UNITED STATES ARMY AVIATION BOARD
Fort Rucker, Alabama

REPORT OF TEST

PROJECT NO. AVN 1162

EVALUATION OF RYANAV IV DOPPLER NAVIGATION
SYSTEM

Figure 3. AFC plotting board

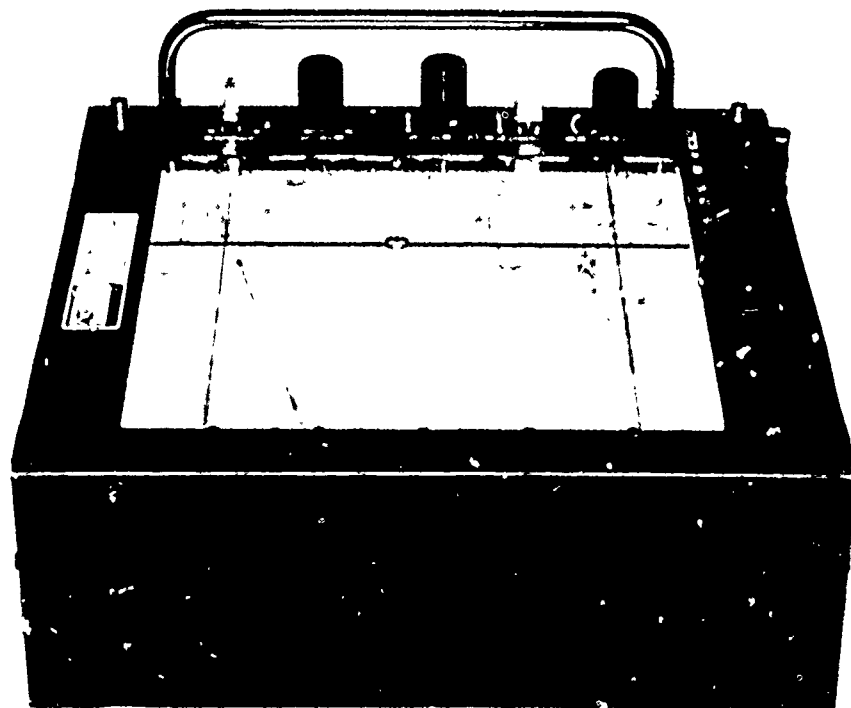
(2) The plotting board (see figure 3) had limited application in this configuration. Templates used in the plotting board covered 40-nautical-mile square areas for charts of 1/500,000 and 80-nautical-mile square for charts of 1/1,000,000. At an average airspeed of 140 knots on a generally straight-line mission, it was necessary to change templates every 17 minutes for the 1/500,000 charts and every 34 minutes for the 1/1,000,000 charts.

Figure 5.
Groundspeed/
drift-angle,
windspeed/wind-
direction indicator

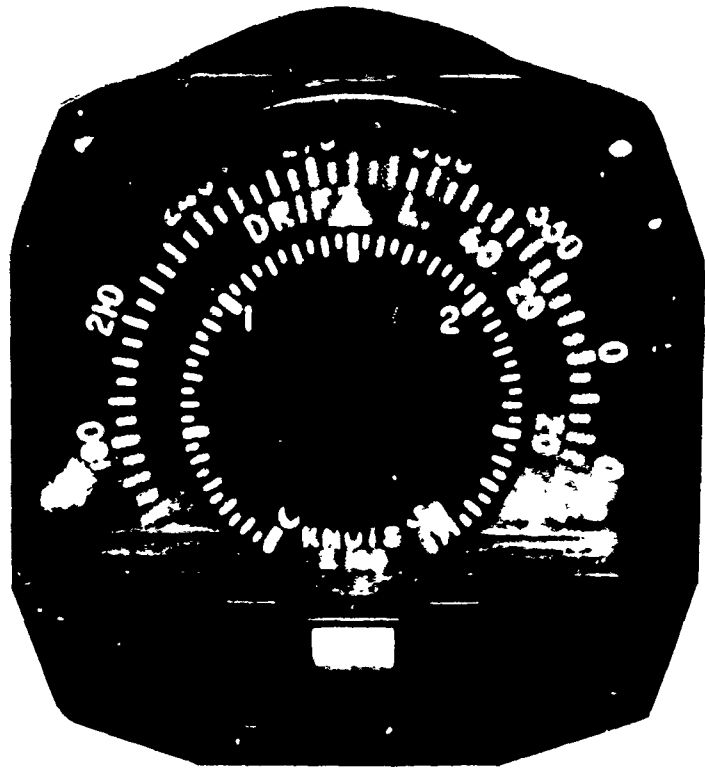
(1) The groundspeed/drift-angle, windspeed/wind-direction indicator (figure 5) was difficult to read and differed from normal instrument presentation in that:

(a) One index served for both wind direction and drift angle, but used two sets of numbers for read-out. The wind direction was shown on a compass card with the numbers on the outside of the card; the drift angle was shown as "Left" or "Right" with the numbers nearer the center of the instruments.

(b) When switching from groundspeed/drift-angle to windspeed/wind-direction, the "knots x 100" pointer oscillated wildly for 5 to 10 seconds before stabilizing.

(c) The outside compass card of the instrument accepted and displayed instantaneous Doppler information without

damping, thus jerking and jumping at intervals of from one to five seconds in increments of five to fifteen degrees. The groundspeed and windspeed pointer varied constantly but in much smoother and smaller increments.

2. Presentation of the groundspeed/drift-angle, windspeed/wind-direction indicator is too complicated and information was displayed erratically and with oscillations.	Redesign indicator with damping incorporated taking into consideration engineering factors with regard to readability and simplicity of the instrument face.

Figure 9. Computer indicator group

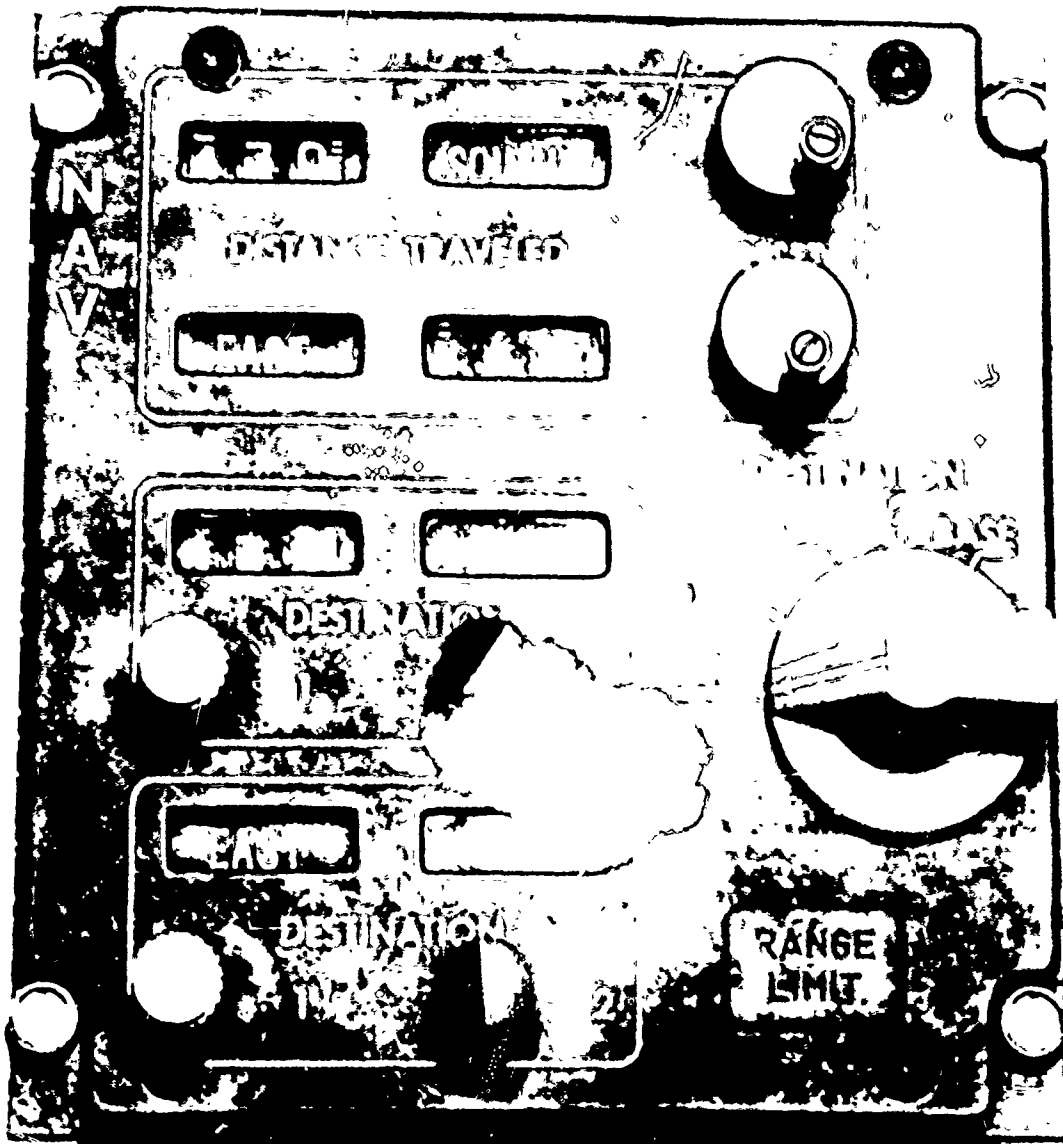
(2) The computer indicator (figure 9) was very difficult to operate in that the controls necessary to set destinations were overly sensitive, and it was extremely difficult to set the desired destination.

<u>DEFICIENCY</u>	<u>SUGGESTED CORRECTIVE ACTION</u>	<u>REMARKS</u>
4. The computer indicator was very difficult to operate in that the controls necessary to set destinations were overly sensitive.	Damp and gear the controls so that they are less sensitive and are not jerky.
